City of Ottawa
Development Review Branch
Grading & Servicing Reviewed

Owner/Applicant
DCR/PHOENIX HOMES
Telephone # 723-9227
Plan # 4M-1593
Project name: DIAMONDVIEW
Civic Address: 208 SILVER DART PR.
House model: NEWINGTON C

LOT 91 **SITE/GRADING PLAN**
DIAMONDVIEW PHASE 3

INDIVIDUAL LOT GRADING REVIEW SUMMARY FOR SITED
HOUSE AS COMPARED WITH OVERALL SUBDIVISION PLAN

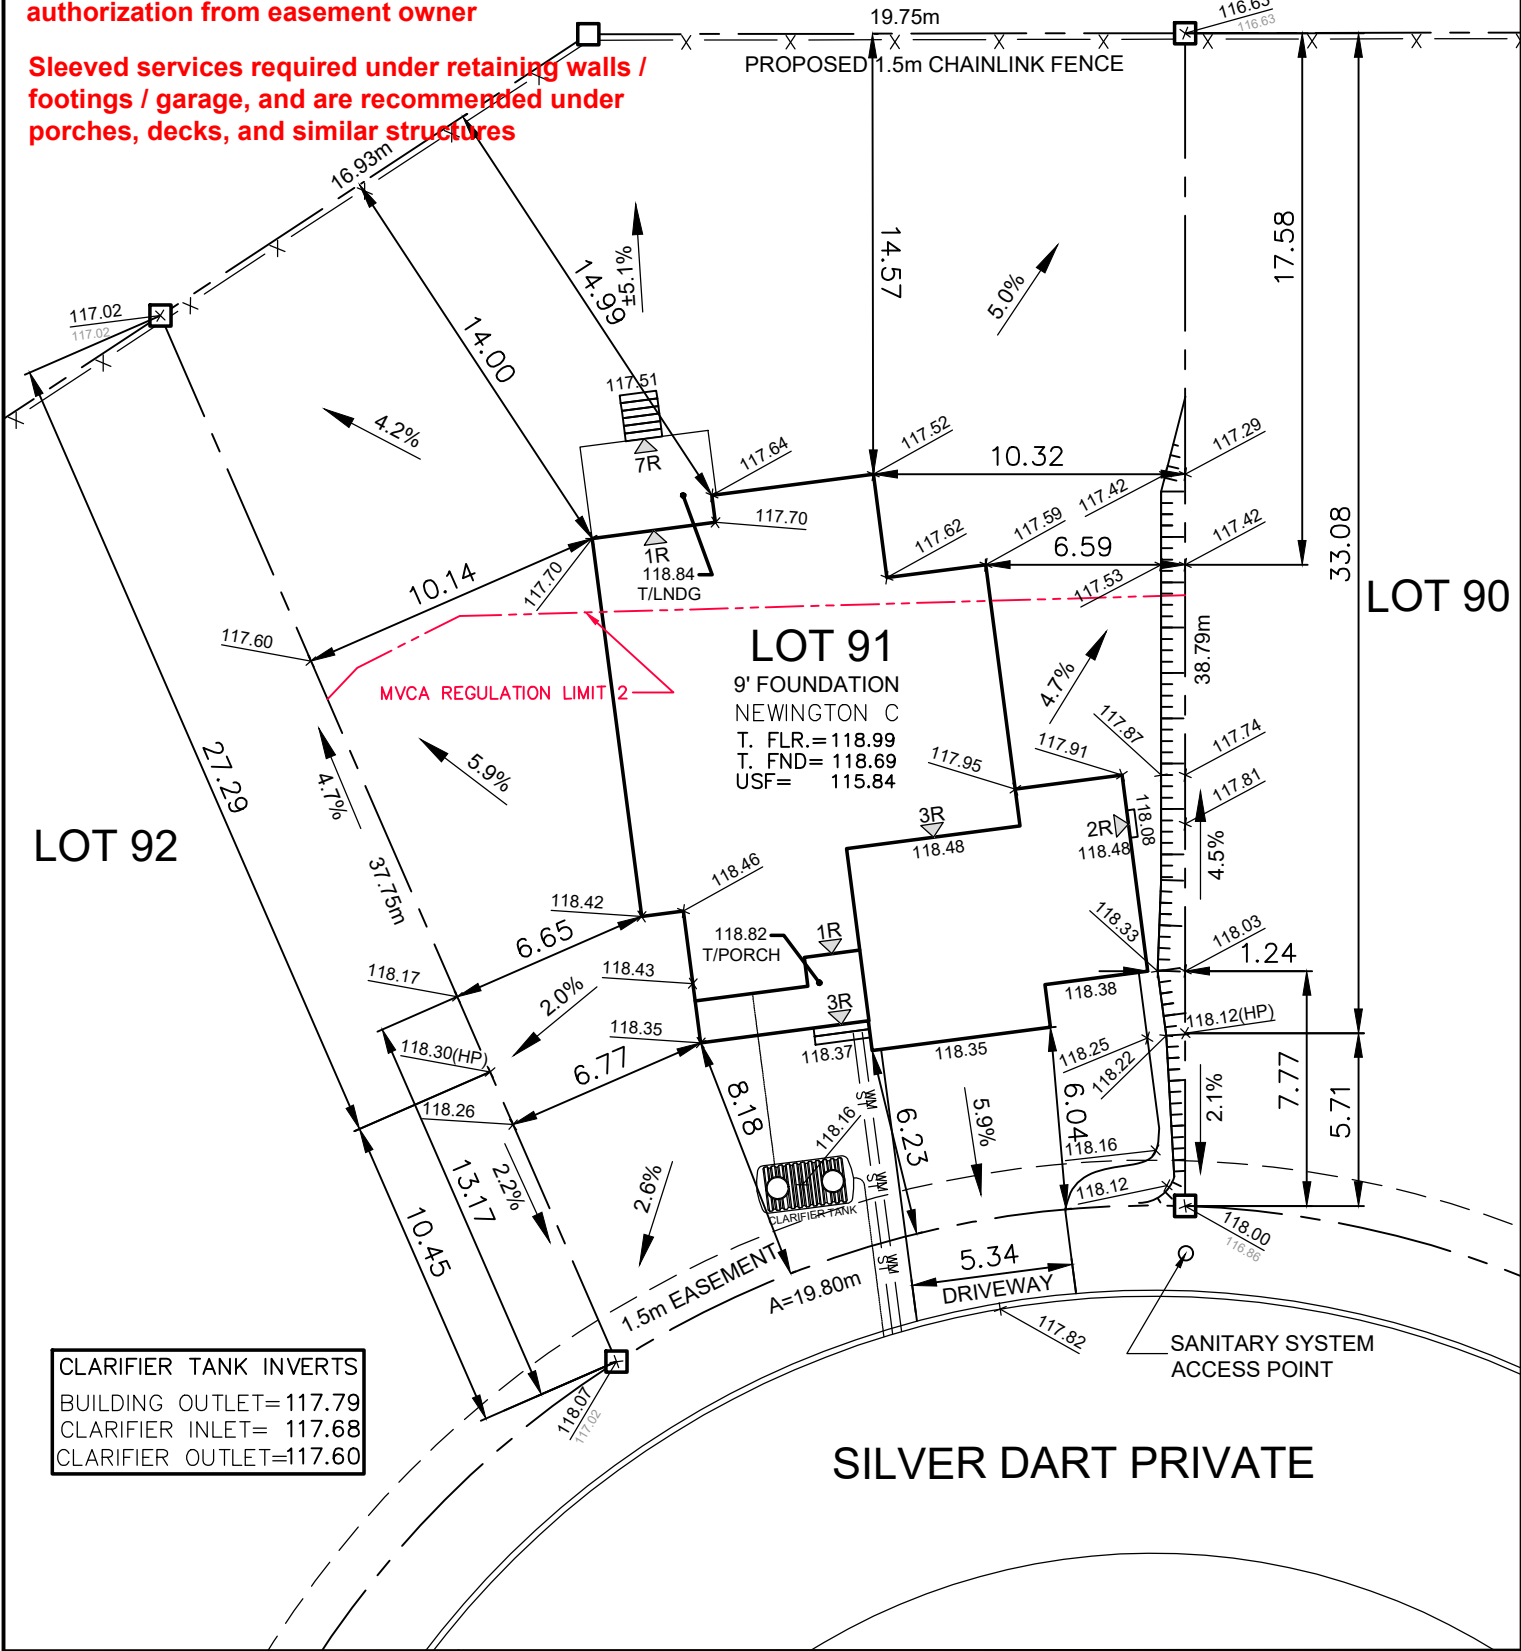
Top of Foundation to be min.
0.15m above final grade

USF to have min. 1.5m cover
around foundation or
foundation shall be insulated

No excess drainage to be directed
towards adjacent properties

Grading to be 2-7%.
Grading over 7% to be
terraced (max. 3H:1V)

Encroachment on or alteration to any
easement is not permitted without
authorization from easement owner

Sleeved services required under retaining walls /
footings / garage, and are recommended under
porches, decks, and similar structures

Roof runoff to be directed toward Right-of-Way
unless otherwise approved. Splash pad to be
provided if downspout within 1.5m of property line
